Value Planning
Final Report

North Central Arizona Pipeline

June 2013

Figure 6 – Cross Section of Proposal Canal

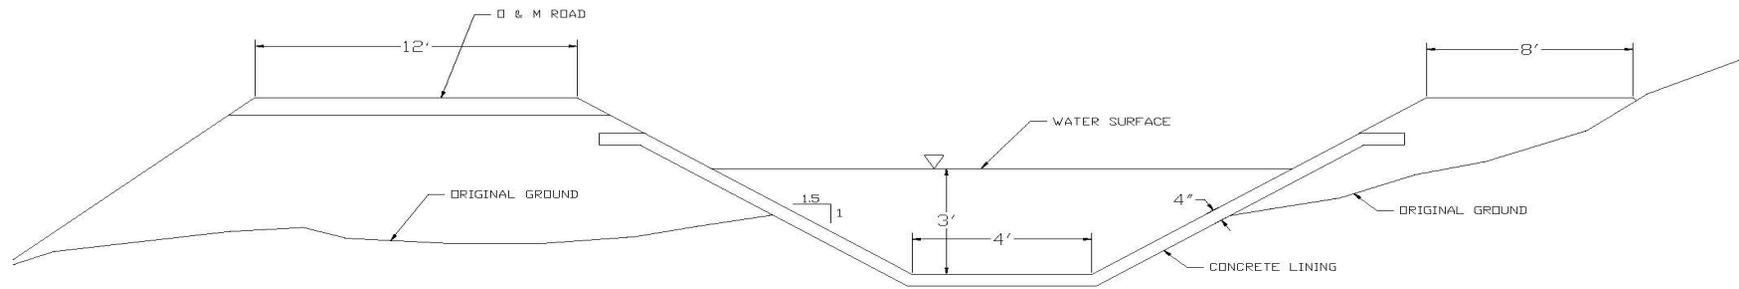
Proposal Description: Consider open canals (Figure 6) to convey the flow to the desired locations in the system in areas where the topography is favorable. Open channels cost less than pipelines to construct. Review of the topography and additional design evaluation is needed to determine if this is a viable option.

Figure 7 – Proposed Open Canal Locations

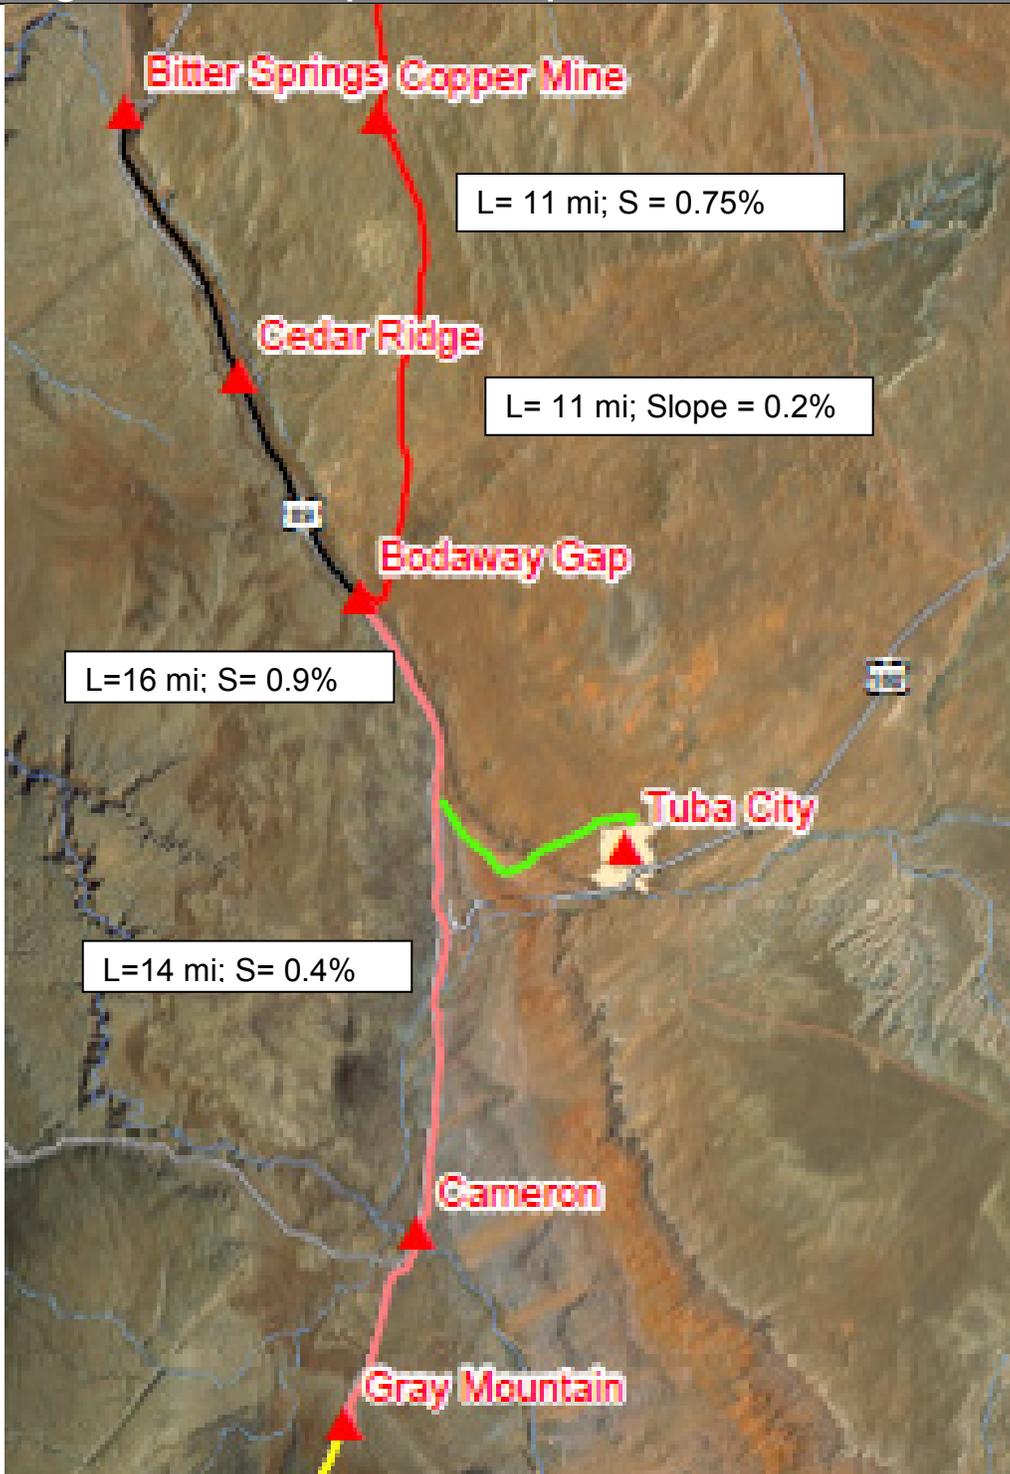
Possible locations to construct canals are shown in Figure 7. Preliminary evaluations indicate that slopes approaching 0.5 percent will result in super critical velocities, which introduces additional concerns and requirements such as reinforced concrete linings, hydraulic effects at lining joints, and energy dissipation structures. In order to maintain sub-critical flow, periodic drop structures would likely be necessary.

Figure 8 – Sketch of Inclined Intake and Vertical Shaft Intake

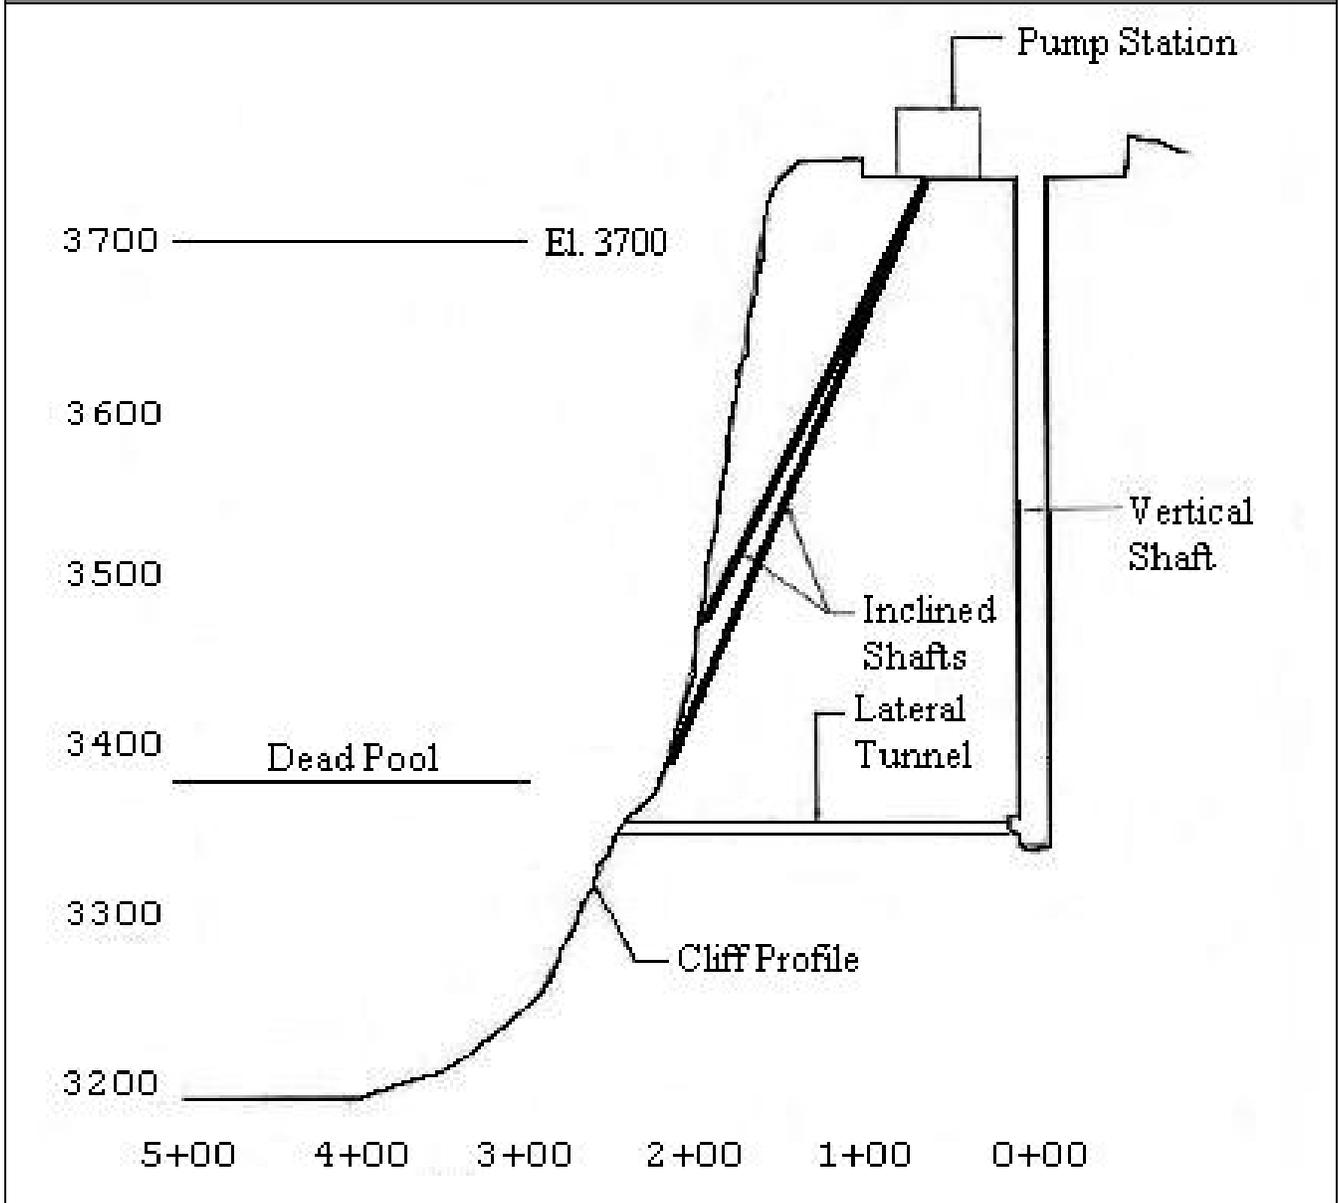
Proposal Description: Consider an inclined constant angle intake system to access a select depth of Lake Powell in conjunction with a reservoir-side pumping plant feature (Figure 8).
